RE: Duluth Airport Authority - Sky Harbor Apron Rehabilitation - Phase 2

ADDENDUM NO 2

C100

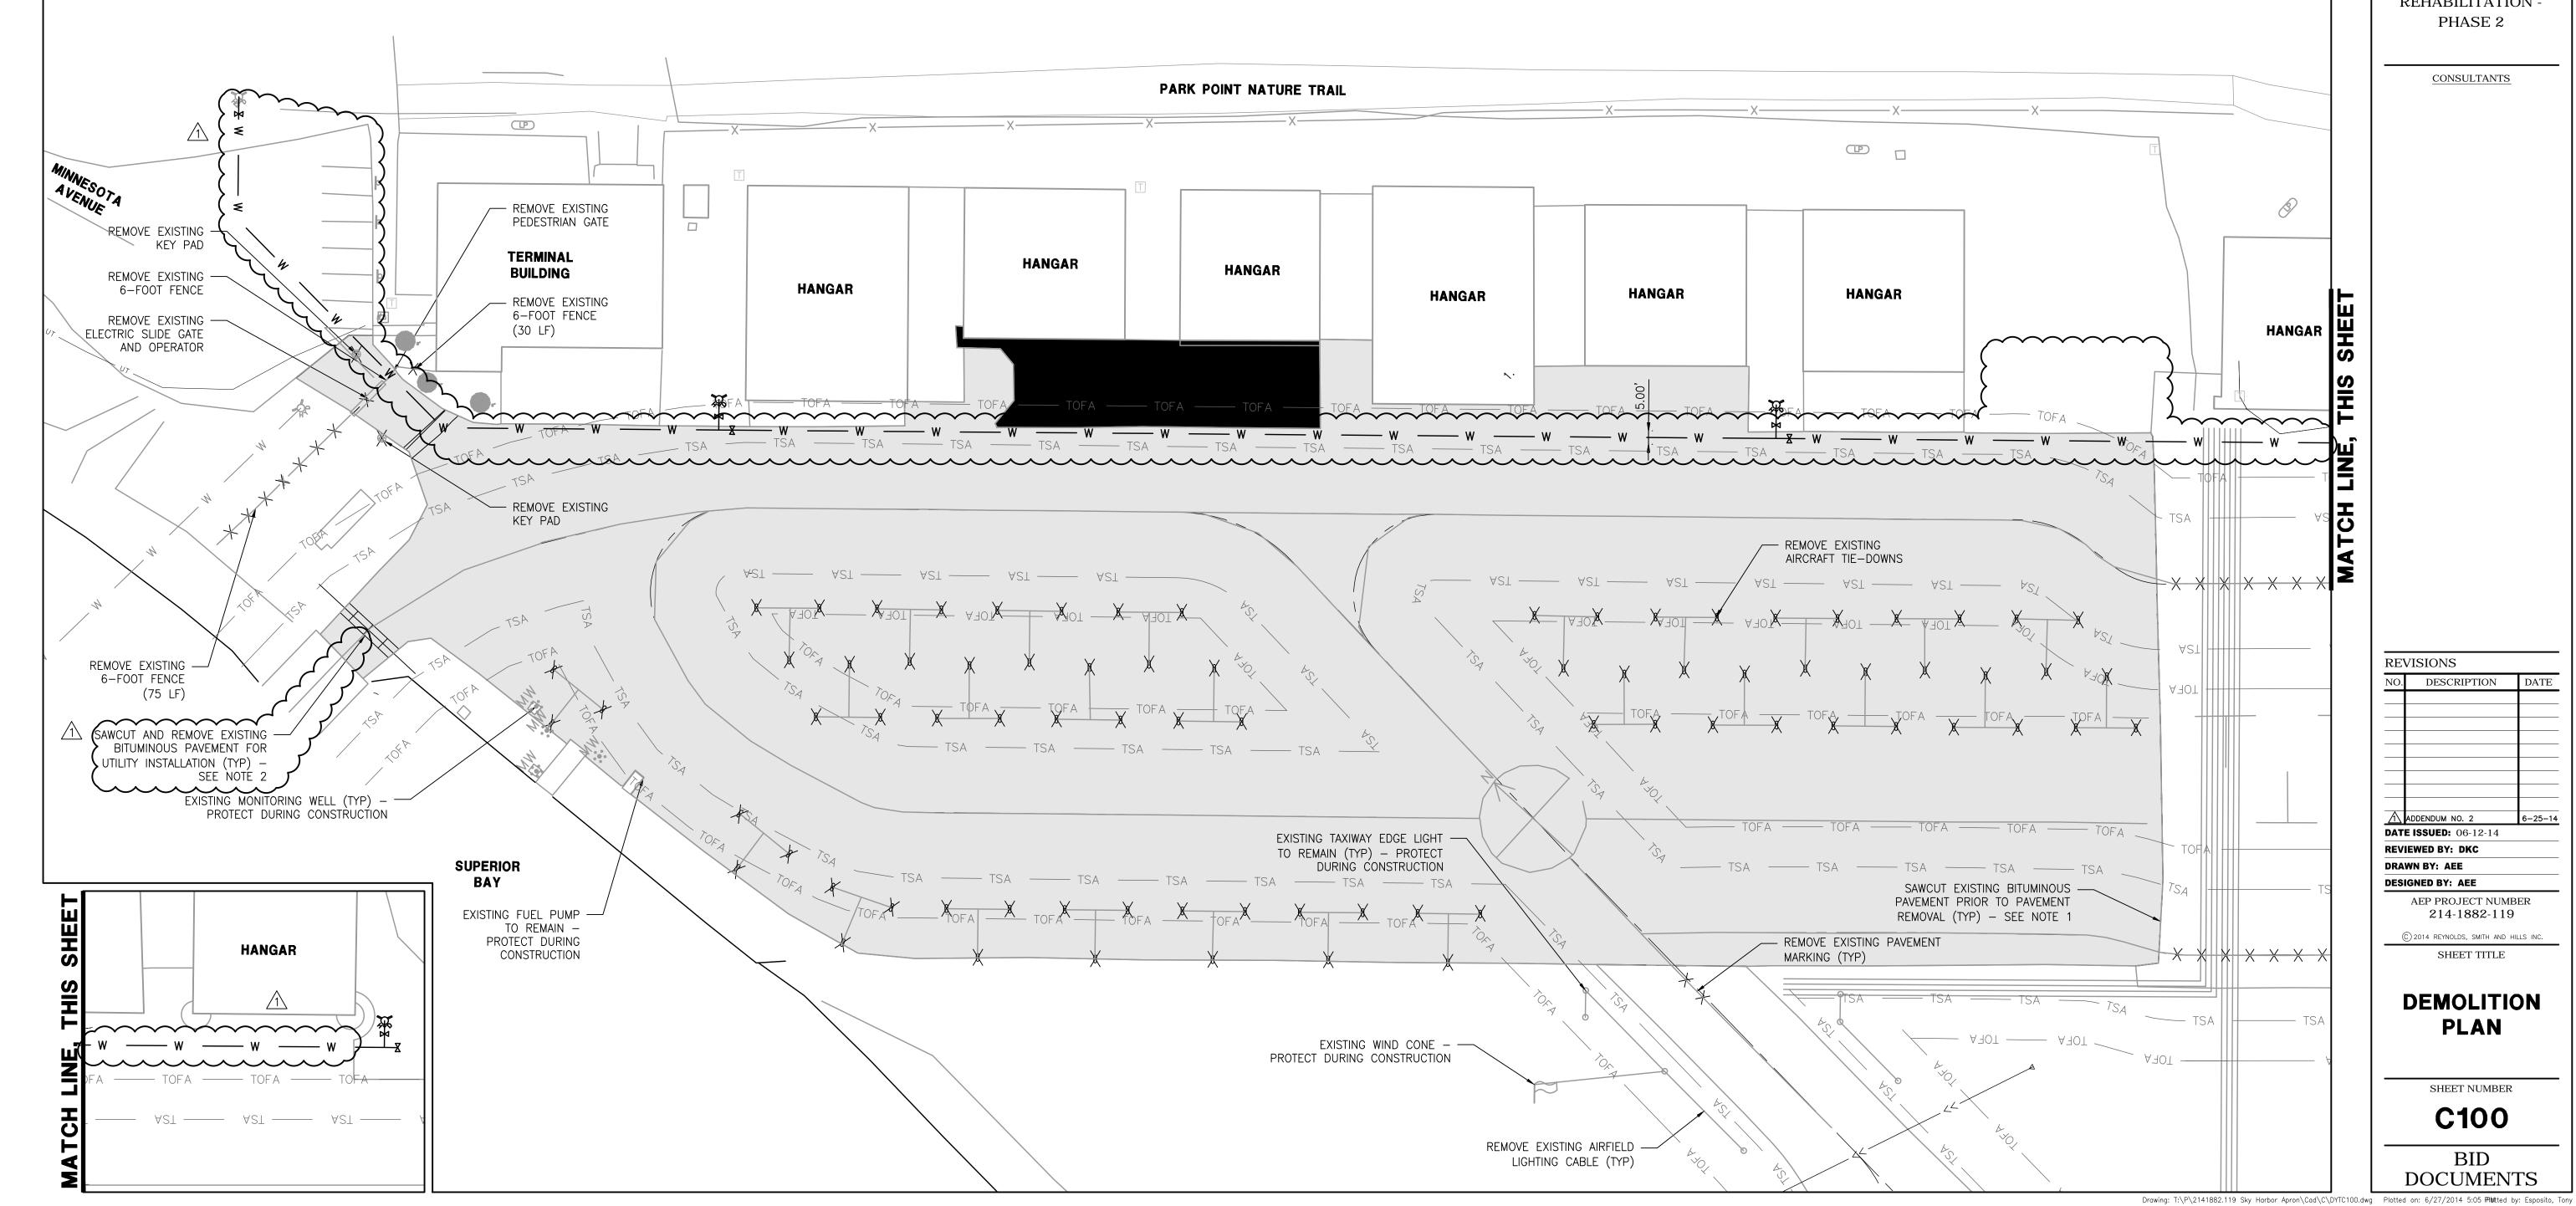
Sheet C100 "Demolition Plan" See Attached. Sheet C700 "Pavement Marking Plan" See Attached Sheet C800 "Utility Plan" See Attached
